**Connell Co-op College,
Alan Turing Way, Manchester
Stage 1/2 Road Safety Audit**

February 2021

- 1.1 Darwin Group as the Scheme Promoter has commissioned Local Transport Projects Ltd (LTP) to carry out a Stage 1/2 Road Safety Audit on proposed improvements to Connell Co-op College in Alan Turing Way, Manchester. As the Highway Authority, Manchester City Council is the Overseeing Organisation.

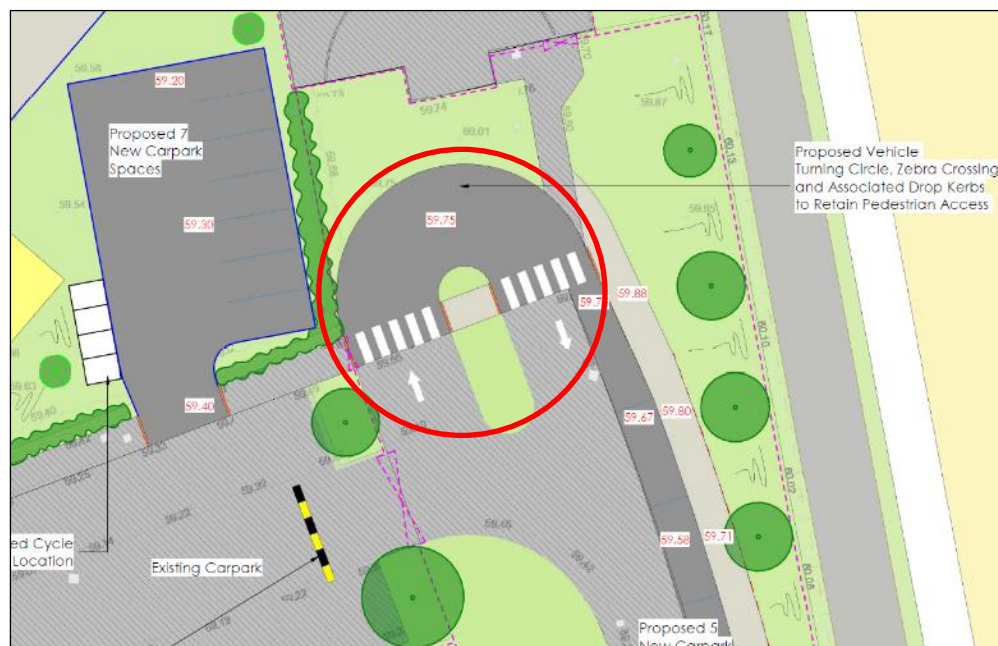
Location: College site.

Summary: Lack of swept path information.

There are no details of swept path information supplied to the audit team. Large servicing vehicles could have difficulty accessing the site with the possibility of encroachment onto footways with the possibility of contact with pedestrians and injury to them.

It is recommended that the swept paths of the largest vehicles expected to use the site are checked.

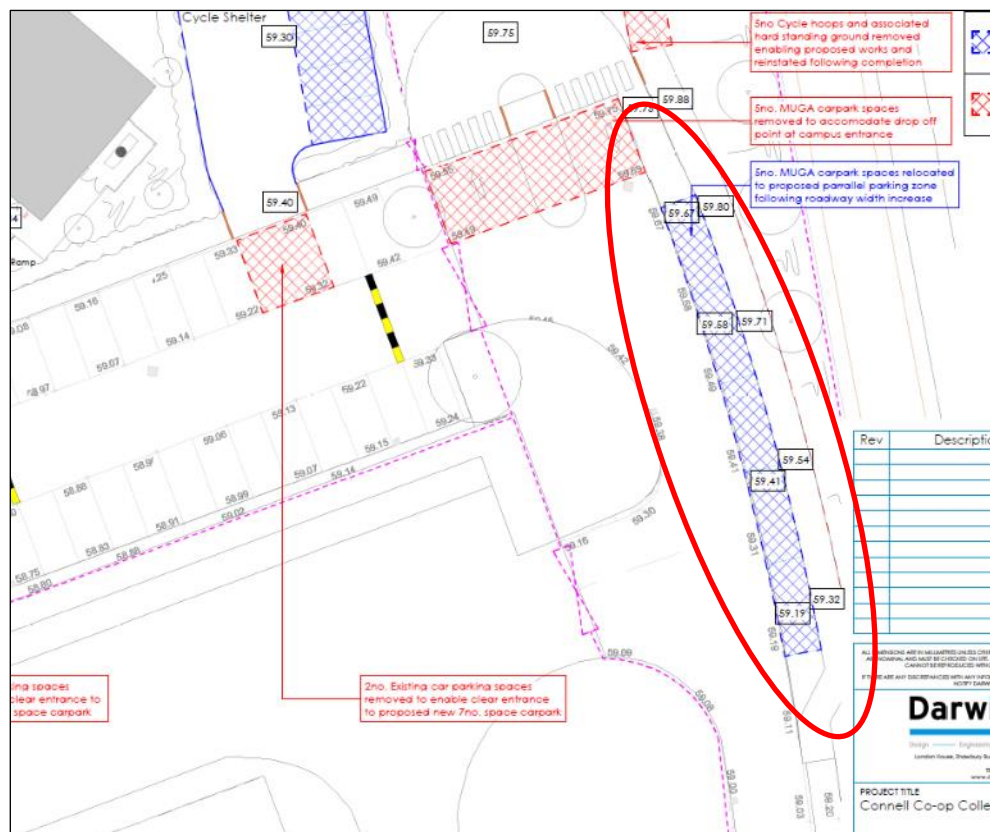
Location: Access road turning circle.

Summary: Lack of drop off / pickup point information.

The access road terminates at a semi-circular turning circle to allow vehicles to turn around after they have dropped off or picked up passengers. However, it is unclear as to where exactly drivers are intended to stop to pick up or drop off passengers. It is possible drivers will elect to stop within the turning circle thereby blocking this facility and preventing other vehicles from progressing. This is likely to result in unsafe vehicle manoeuvres and possible vehicle / vehicle or vehicle / pedestrian contact with the possibility of injury to vehicle occupants and pedestrians.

It is recommended that no stopping restrictions are implemented within the turning circle based on the vehicle swept path requirements.

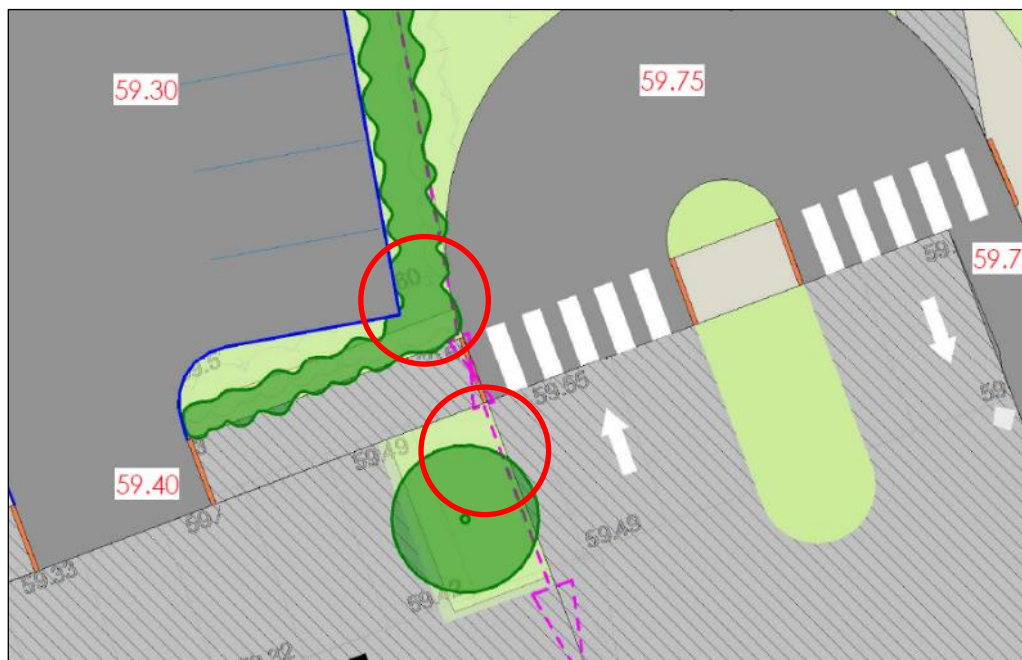
Location: The access road.

Summary: Unclear function of parking bays adjacent to access road.

There are five parking spaces proposed on the east side of the access to the college; it is unclear as to their function and whether the spaces are available at all time, or only for a specific time/purpose. Reserving them for pick up / drop off only would help to reduce the likelihood of drivers double parking and blocking the access, increasing potential for conflict and risk of injury to vehicle occupants and pedestrians.

It is recommended that the five parking spaces on the east side of the access road are reserved for drop off / pick up only.
